<b>Docket Number:</b>	06-AFC-09C
<b>Project Title:</b>	Colusa Generating Station - Compliance
<b>TN #:</b>	203611
<b>Document Title:</b>	Application for Staff Approved Project Change to Amend Docket - Steam Turbine Deck Grating
<b>Description:</b>	N/A
<b>Filer:</b>	Charles Robert Price
<b>Organization:</b>	Pacific Gas & Electric Co.
<b>Submitter Role:</b>	Applicant
<b>Submission Date:</b>	2/6/2015 9:21:26 AM
<b>Docketed Date:</b>	2/6/2015

**Subject: Petition To Amend The Commission Decision For The Colusa Generating Station.**

## **COLUSA GENERATING STATION APPLICATION FOR STAFF APPROVED PROJECT CHANGE**

ST/G AREA UTILITY BRIDGE  
GRATING & GUARDRAIL PIPE OPENINGS &  
SUPPORT STEEL EL 142'-0" & 151'-2"

COLS-1-DW-159-503-112

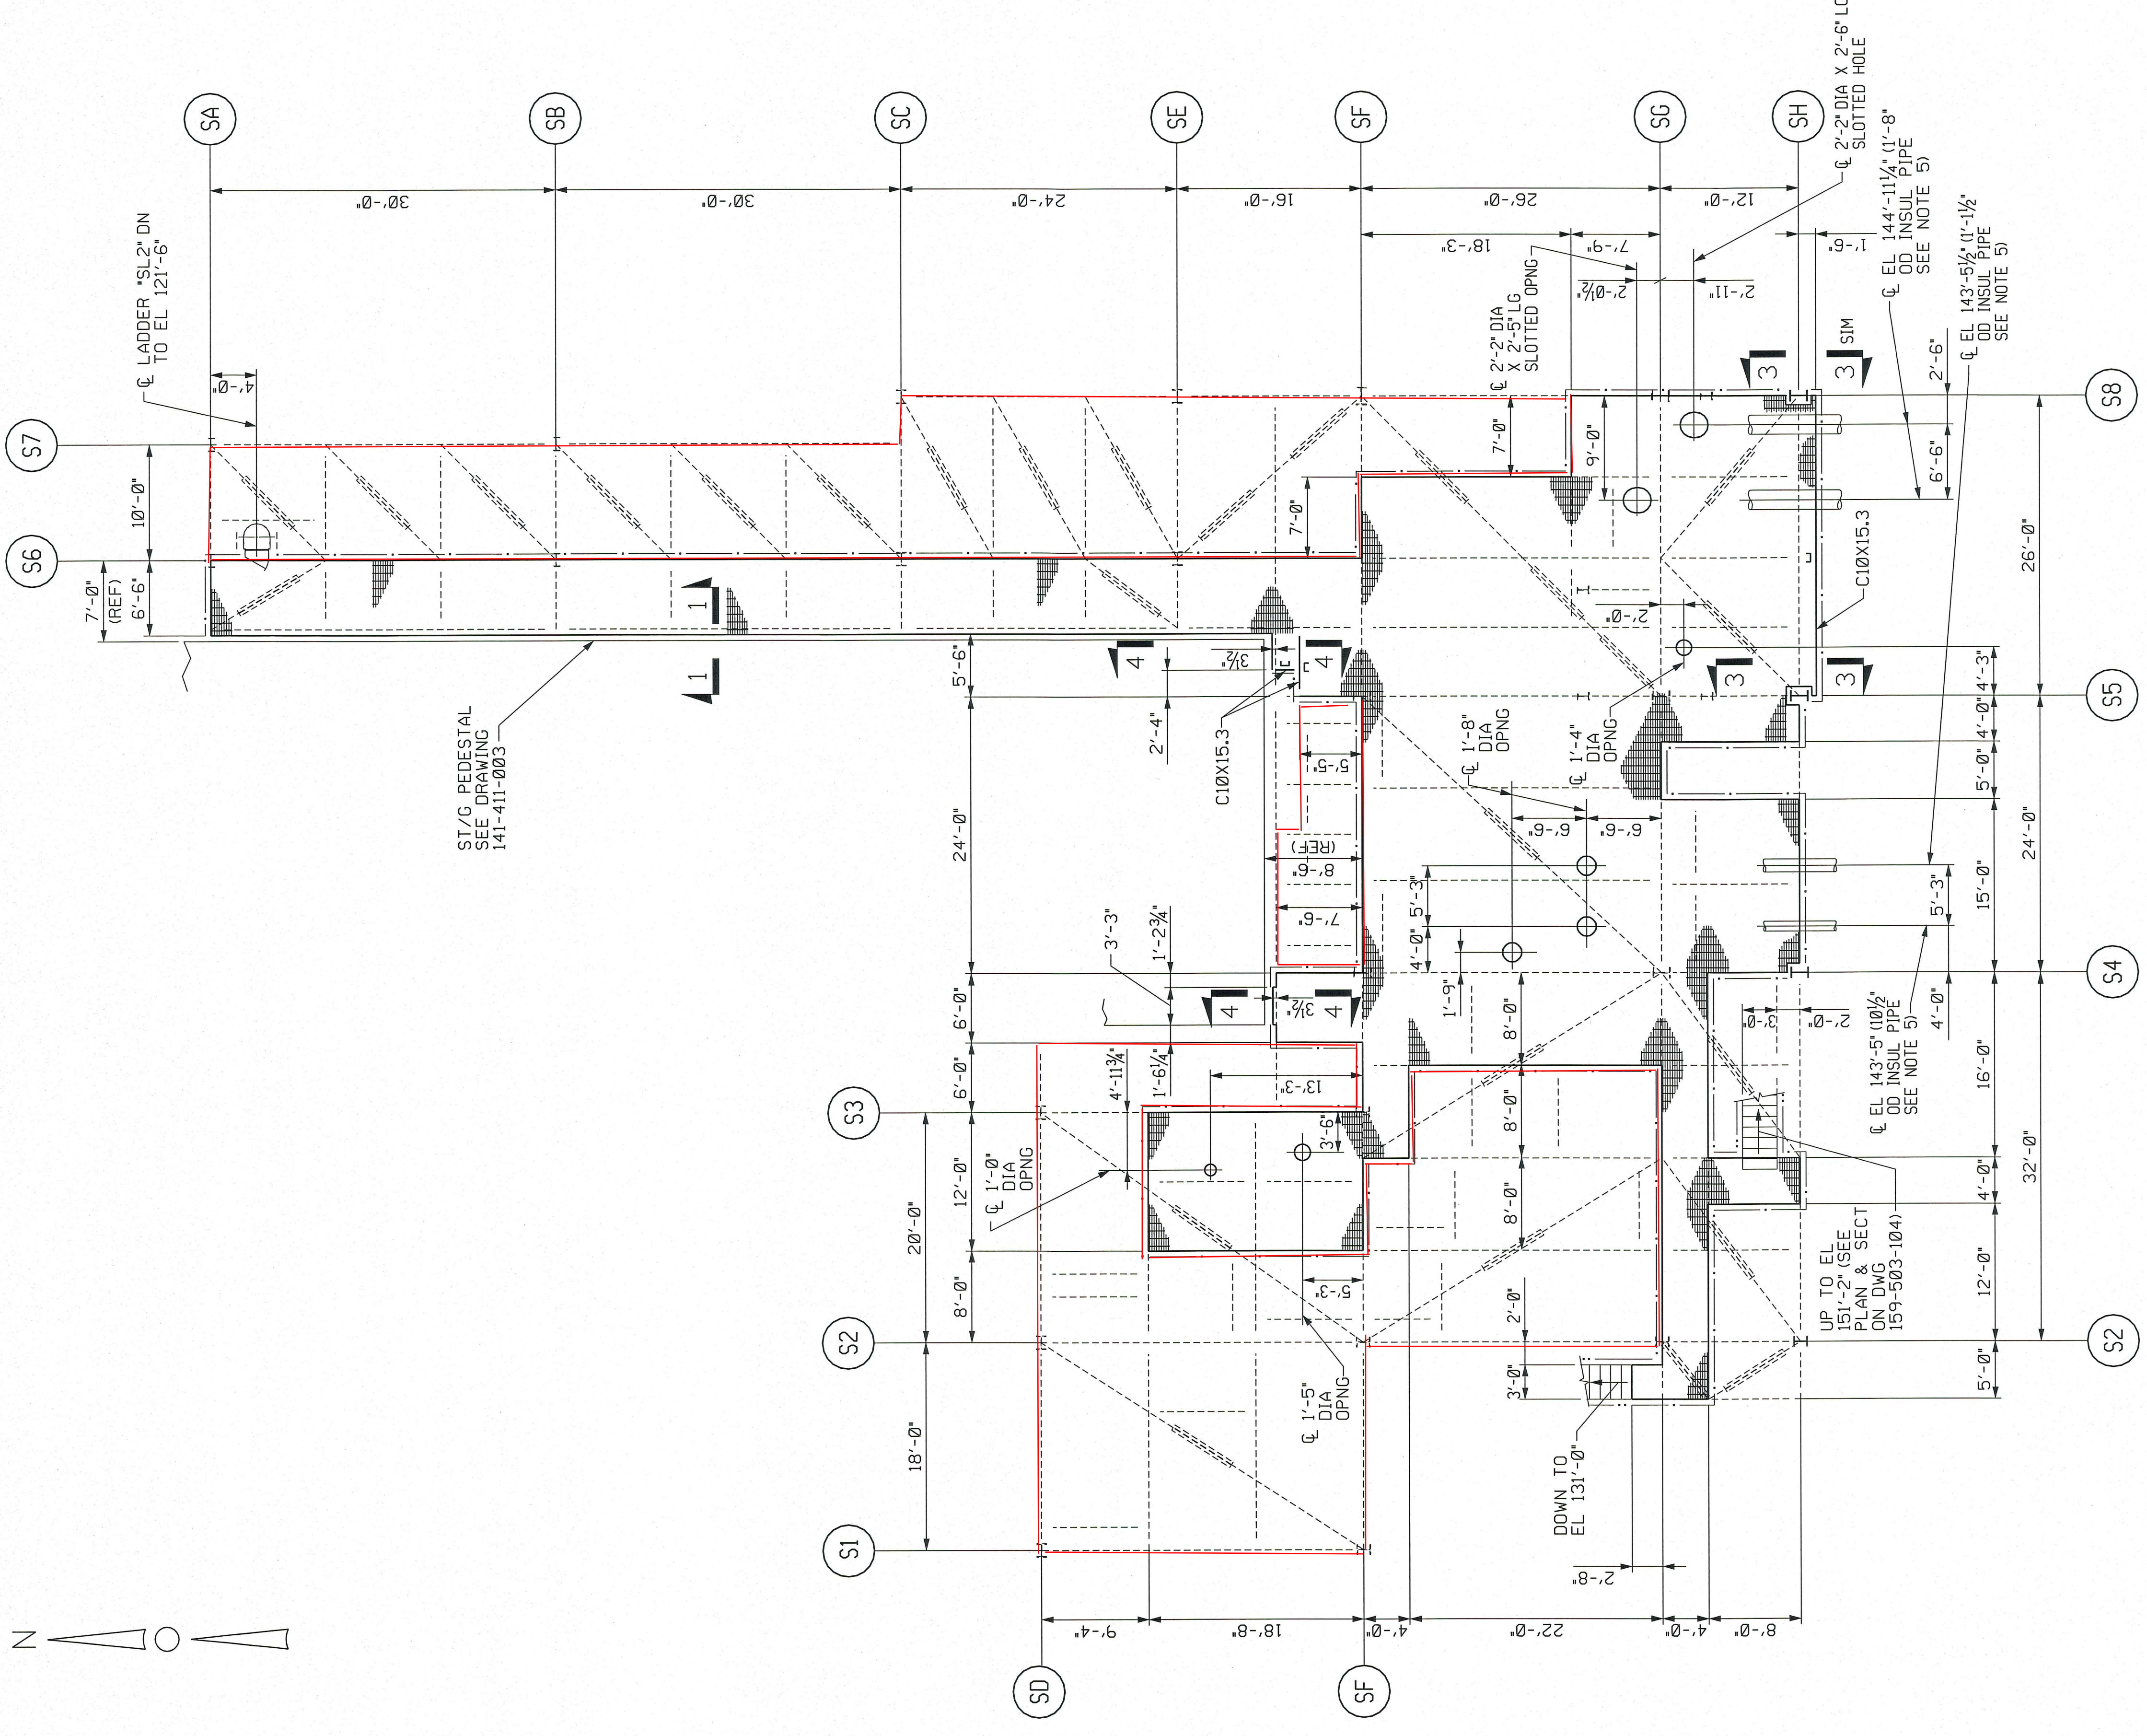
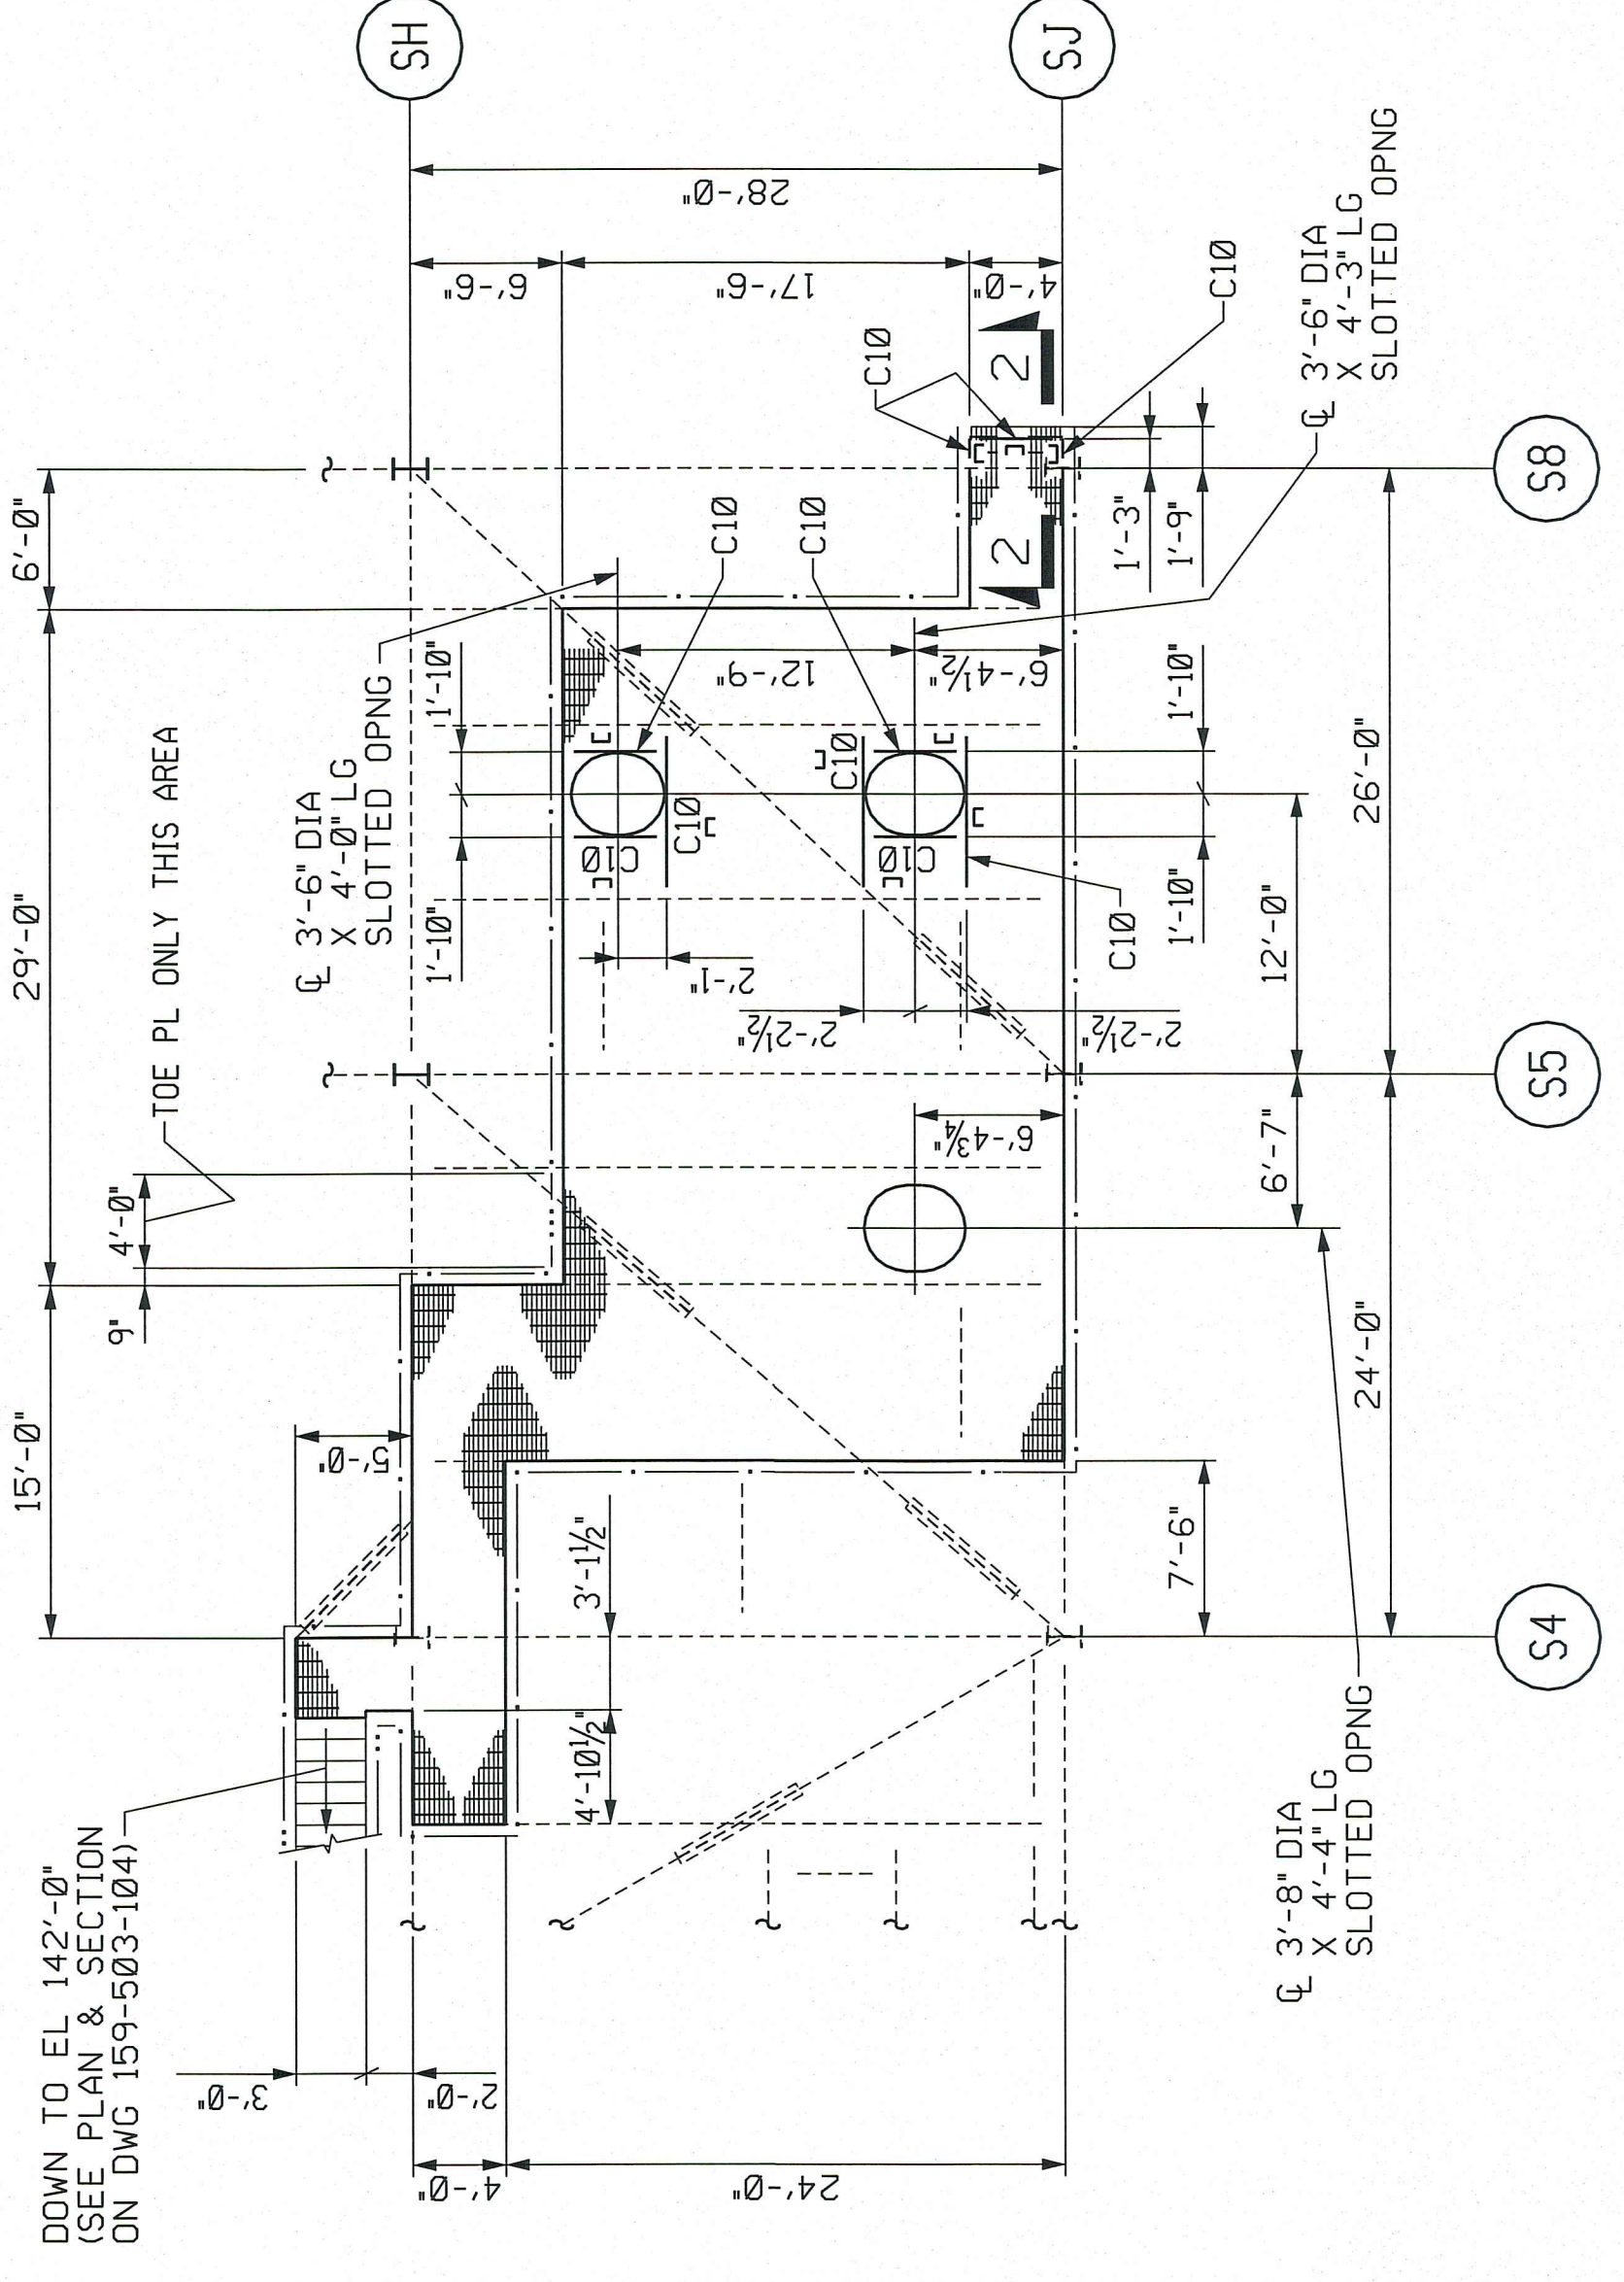
The CGS plans to install additional grating on the Steam Turbine deck to increase the useful area of the workspace.

This grating will allow crews working on the Steam Turbine or its associated Generator to work more safely and efficiently by creating more work space. Currently a limited amount of tools and equipment can be stored on the deck during maintenance resulting in unnecessary trips up the stairs for crew along with a greater amount of crane hoists required.
